Work Order ID 92460

Item Name: Replacement Skidtube

DRAWING NO. D2580
TITLE 205 SKIDTUBE ASSEMBLY
REV. E
SHEET 1 OF 8
SCALE NTS

DRAWING NO. D2580	TITLE 205 SKIDTUBE ASSEMBLY	REV. E	DART AEROSPACE LTD ENGINEERING ORDER	D.E.O. NO. D2580-E-1	SHEET NO. SHEET 1 OF 1	SCALE NTS
DRAWN <i>JP</i>	CHECKED <i>ASS</i>	MFG. APPR. <i>ER</i>	APPROVED <i>[Signature]</i>	DE APPR. <i>[Signature]</i>		
DATE 11.12.13	DATE 11.12.13	DATE 11.12.13	DATE 11.12.13	DATE 11.12.13

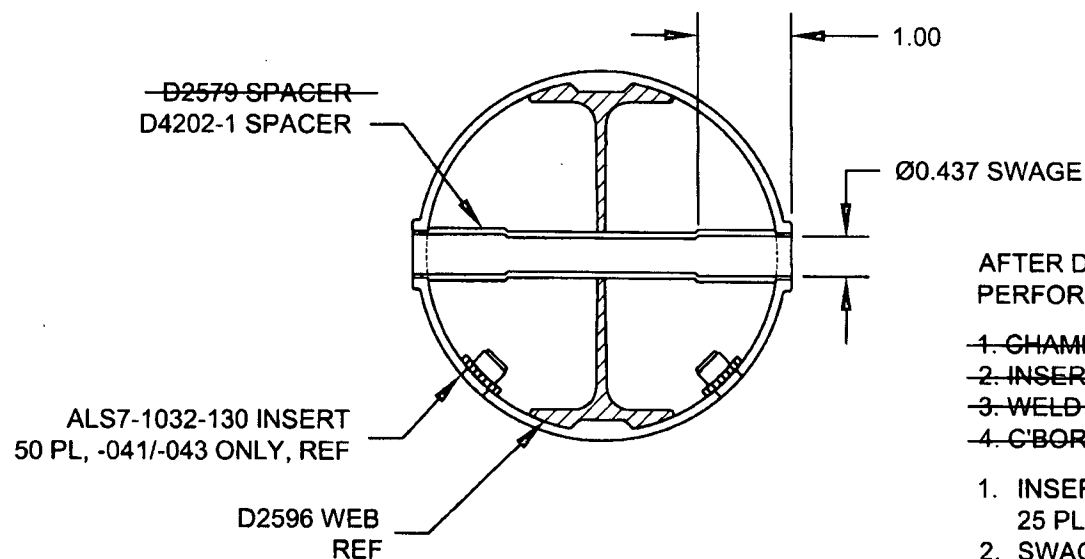
CHANGE ALL C'BORED WELDED CROSSBOLT SPACERS TO SWAGED SPACERS

SECTION B-B, SECTION F-F, & SECTION I-I ARE AMENDED AS FOLLOWS
FOR ALL HOLES THAT WERE ORIGINALLY C'BORED:

*** FOR -045 SKIDTUBE ONLY:**

WELD 4X D2579 SPACERS PER DWG
IN LOCATIONS MARKED "NO C'BORE".
REF SHEET 4 OF DWG.
